# Attachment A – Request for further information / clarification

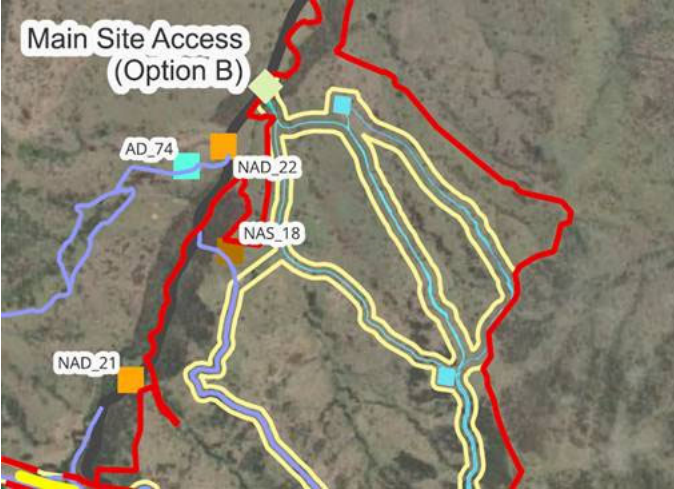
| Item   | Request for information / clarification   |
|--|---|
| <p><b>APPENDIX 1</b><br/>General layout of the development</p> | <p>The Commission requests the following clarifications on the provided map:</p> <ul style="list-style-type: none"> <li>• Include consistent wind turbine labelling (ie. explanation and consistent use of acronyms including WTG and WP) to improve legibility;</li> <li>• Include clarification of legend items to avoid conflicting colours/graphics on the map;</li> <li>• Legend to include all items illustrated on the map; and</li> <li>• Clarification of the ‘temporary footprint’ and ‘development corridor’ located near Main Site Access (Option B):</li> </ul>  |
